To: T10 Technical Committee
From: Rob Elliott, HP (elliott@hp.com)
Date: 17 March 2006
Subject: 06-161r0 SAS-2 Alternate icon

sas2r02 - Serial Attached SCSI - 2 (SAS-2) revision 2

Figure A.1 — SAS icon

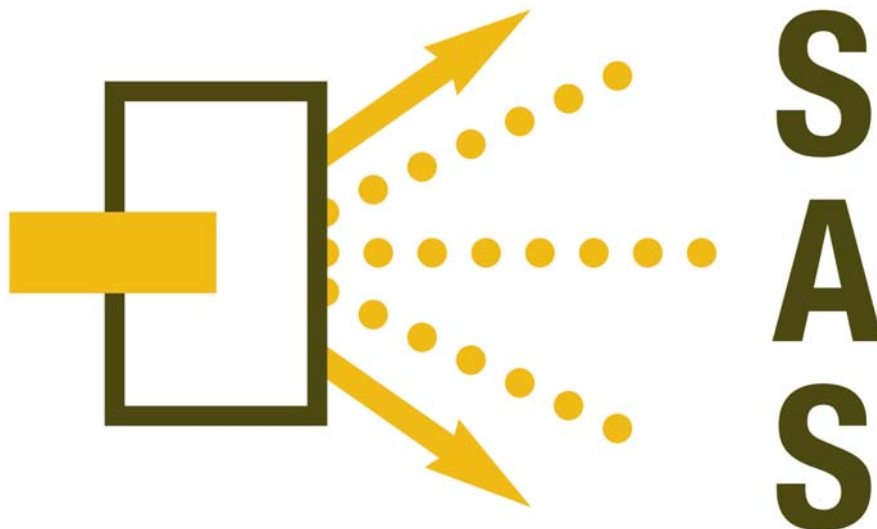
The icon in SAS-1 and SAS-1.1 includes small dots that may be difficult to print/manufacture/read in small renditions. Also, color is not always available.

Figure A.1 shows the ~~general~~primary SAS icon. ~~This icon should be included on or near all connectors used by devices compliant with this standard.~~

[Figure A.2 — SAS alternate icon](#)

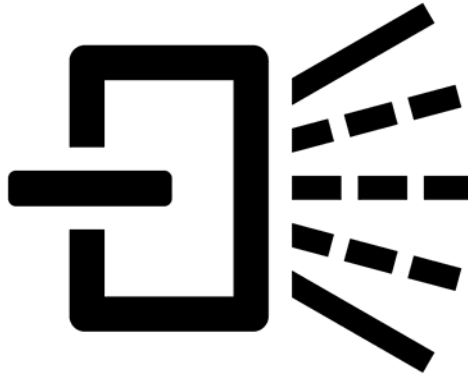
A simplified alternate monochrome icon is proposed for use where the primary icon cannot be used.

[Figure A.2 shows an alternate SAS icon that may be used instead when the area for the icon is small.](#)

[Figure A.3 — SAS alternate icon with SAS letters](#)

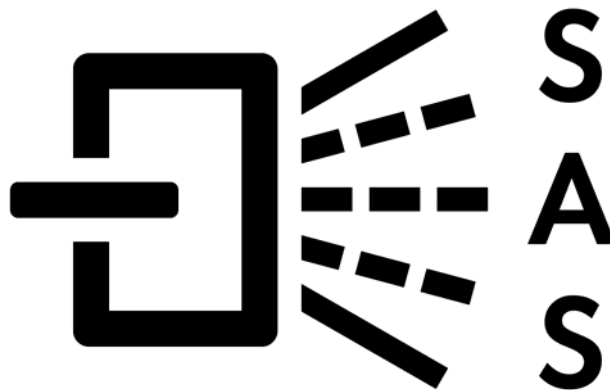
[Figure A.3 shows the alternate SAS icon with the SAS abbreviation alongside.](#)
